**ADDENDUM NO. 3
JANUARY 15, 2025
FOR
ROOSEVELT PARK POOL EQUIPMENT UPGRADES
MINOT PARK DISTRICT
MINOT, ND
DECEMBER 2024**

This addendum consists of four (4) pages and one (1) attachment.

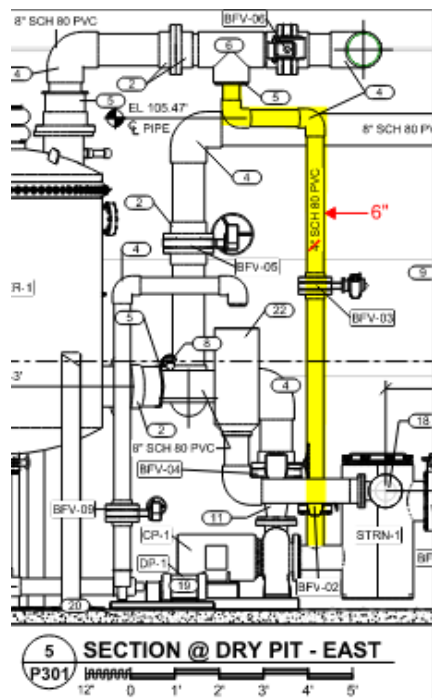
- 1) 5/P301 - SECTION @ DRY PIT - **Revise** precoat line from 4" to 6" per sketch below.

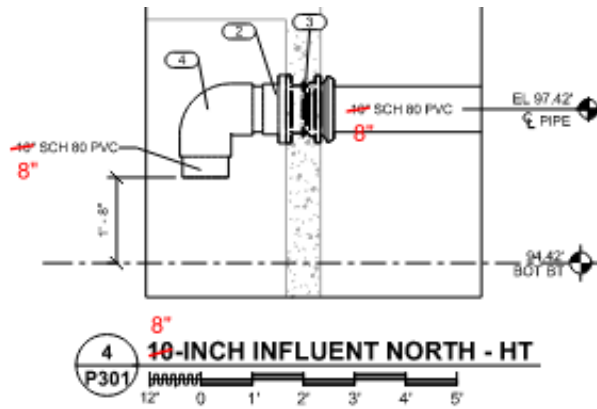
- 2) 4/P301 - 10-INCH INFLUENT NORTH - HT - **Revise** pipe size to 8".

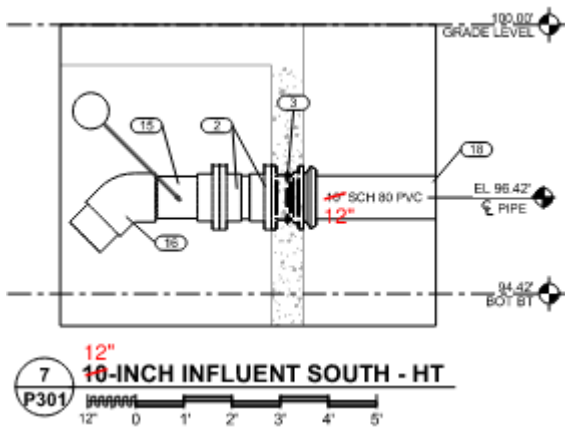
- 3) 7/P301 - 10-INCH INFLUENT SOUTH - HT - **Revise** pipe size to 12".
